Service Bulletin

Subject: MILKY SUBSTANCE ON OIL LEVEL GAUGE (DIPSTICK)	Bulletin No: 01-050/06
	Last Issued: 11/21/2006

This bulletin supersedes the previous bulletin 01-009/05, issued 2/7/2005. The APPLICABLE MODEL(S) / VINS, DESCRIPTION, REPAIR PROCEDURE and PART(S) INFORMATION sections have been changed.

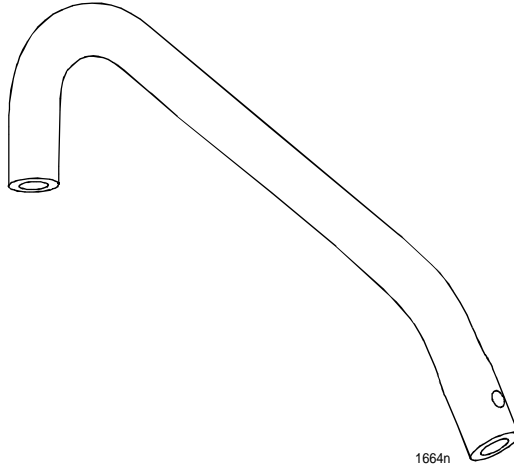
- Remove and discard the existing hose from between the intake air hose and the oil filler pipe.

**DISCARD OLD HOSE FROM
BETWEEN INTAKE AIR HOSE
AND OIL FILLER PIPE**

**DO NOT DISCONNECT THROTTLE
BODY HOSES-TIE WRAP THROTTLE
BODY TO BRACE AS SHOWN**

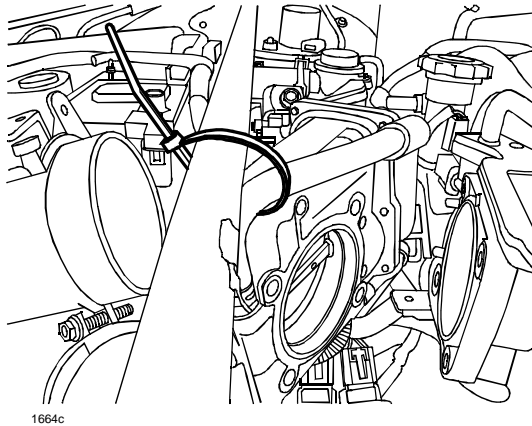
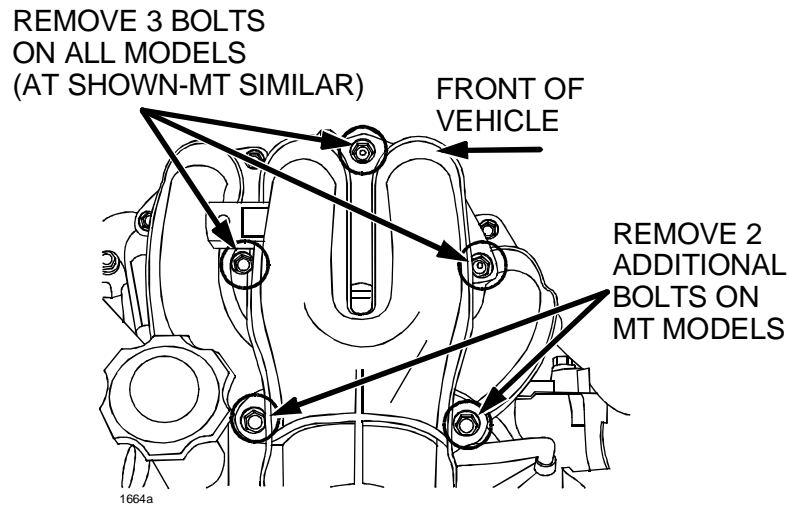
4. Remove throttle body bolts and tie-wrap throttle body to the strut tower brace.

- DO NOT disconnect the throttle body coolant hoses.
